Rover "K" Series - Cylinder Head Gasket

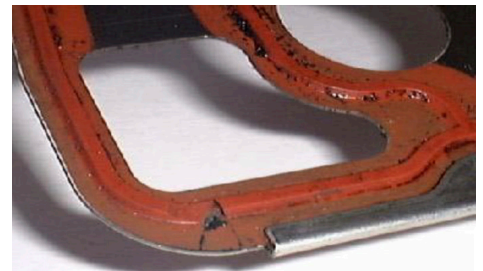
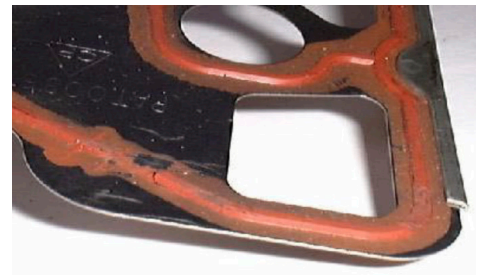
- Cuts/tears in SAC track (silicon bead) on the cylinder head side, often towards the front left and right hand corners of the gasket

- Careless opening of gasket packaging.
- Misalignment of the cylinder head with dowels whilst re-fitting the head, with engine still in the vehicle.

- Do not use sharp blade to open gasket packaging
- Assemble gasket carefully onto engine. Enlist the help of a colleague when lowering the head onto the location dowels.
Note: It is often easier to re-fit the head with all manifolds removed.

Original

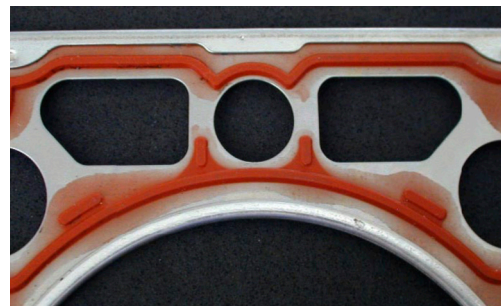
- The "K" series engine is also known for problems caused by oil seepage around number one bore eyelet and into the coolant gallery. This condition results from damage (or omission), during gasket replacement, of the original plastic dowel.
- To eradicate this problem the silicon bead has been modified (see photograph) and the plastic dowel replaced with a steel dowel (Rover - part number LYU100010).
